9 Ecology

Cobbora Coal Project - Preferred Project Report and Response to Submissions

9.2 Response to submissions

Figure 9.1

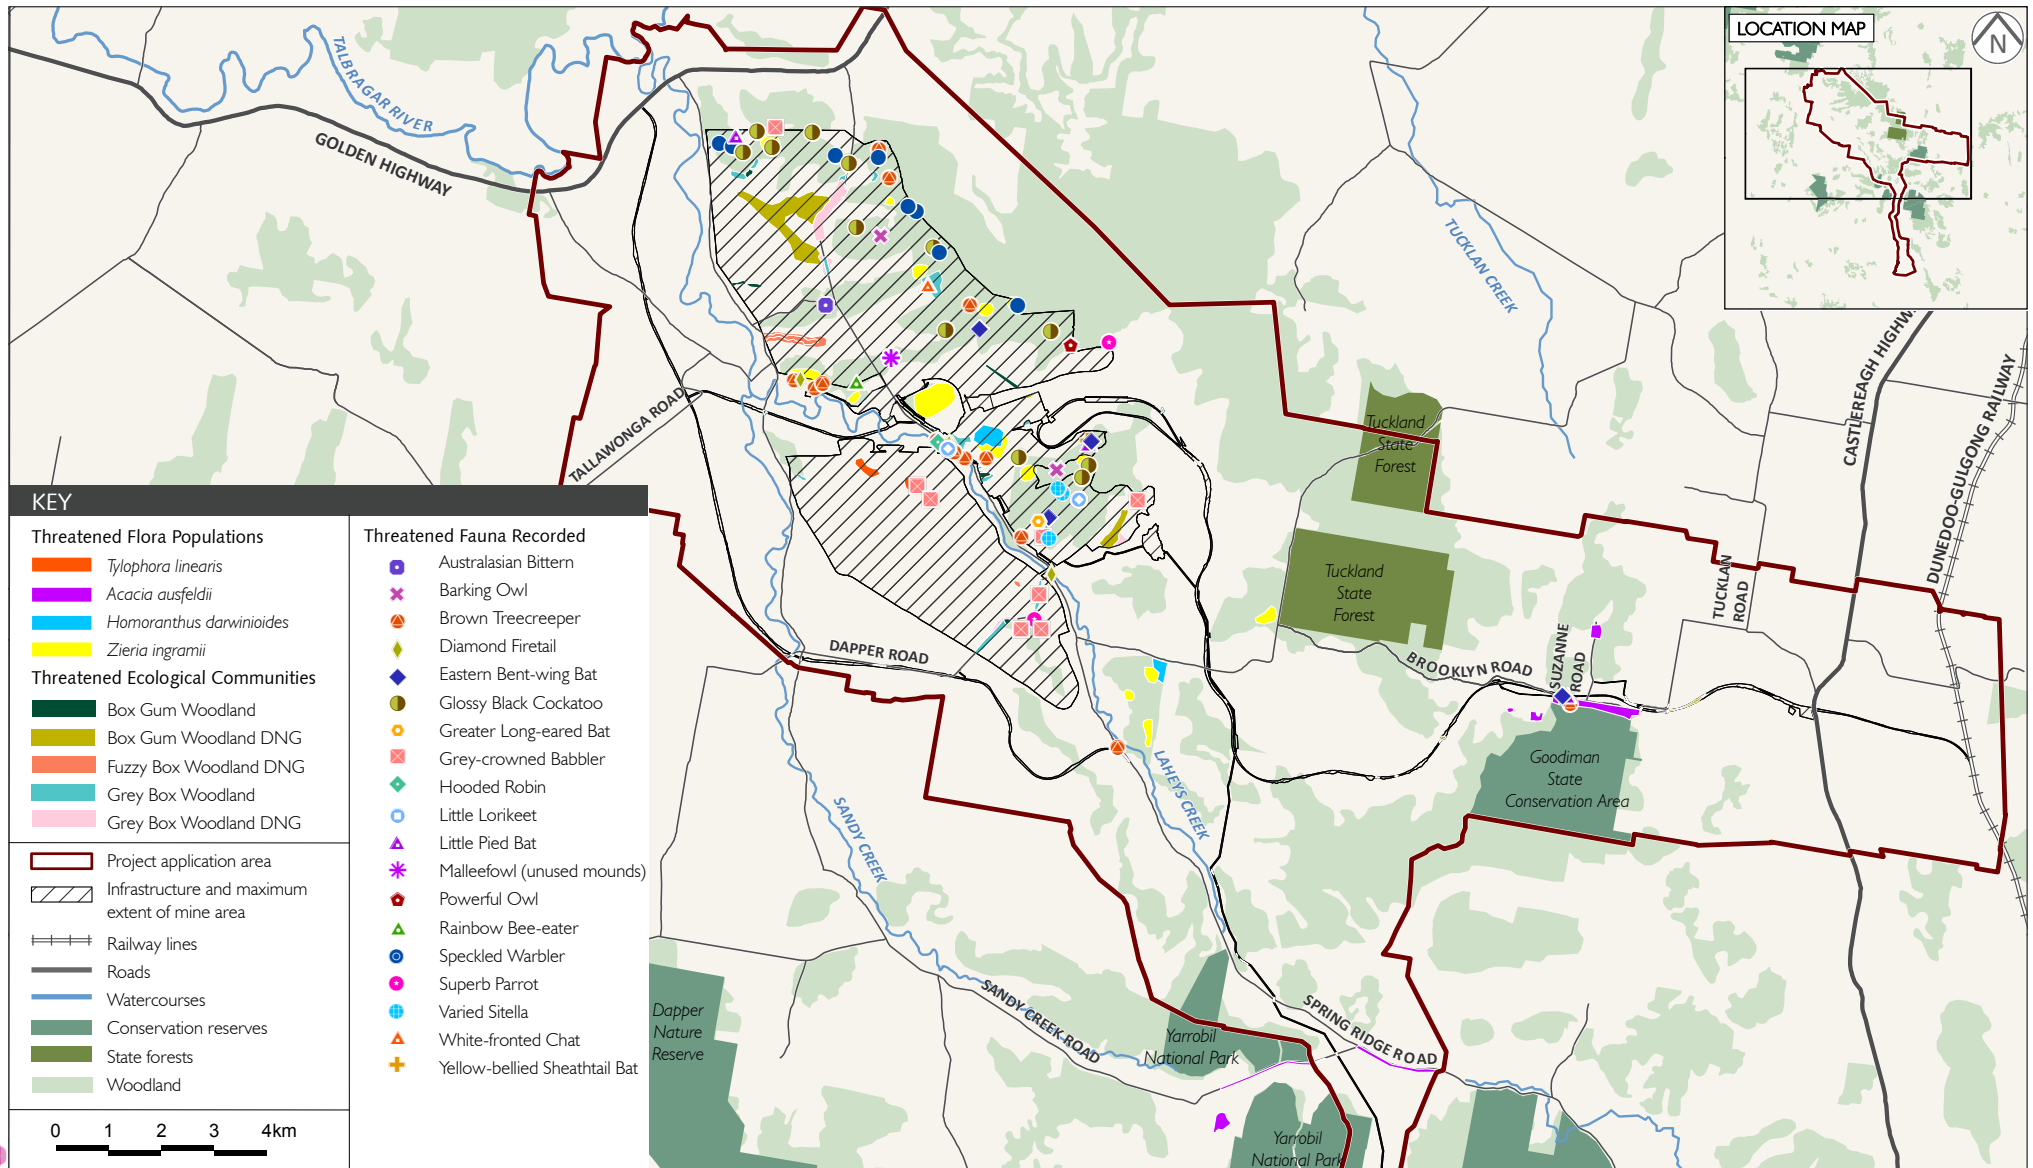
The area of native pasture in low condition in the Project area has increased by 81 ha to 1,048 ha (Table 9.1 and Figure 9.1). This represents roughly 35% of the native pasture identified in the PAA and is an increase of about 8% from the original Project footprint. In addition to this, 153 ha of native pastures in a moderate condition are considered to represent grasslands derived from Box Gum Woodland, Fuzzy Box Woodland or Grey Box Woodland, which are all listed as threatened ecological communities (see Figure 9.1).

Fauna crossings have been shown to be effective for a range of species (Bond and Jones 2008; Hays and Goldingay 2009). The underpasses will be designed to allow large macropods to move through, but will also accommodate the movement of a range of other species. The proposed overpass near Goodiman SCA will be vegetated to promote the movement of small woodland birds and other fauna (Figure 9.1).
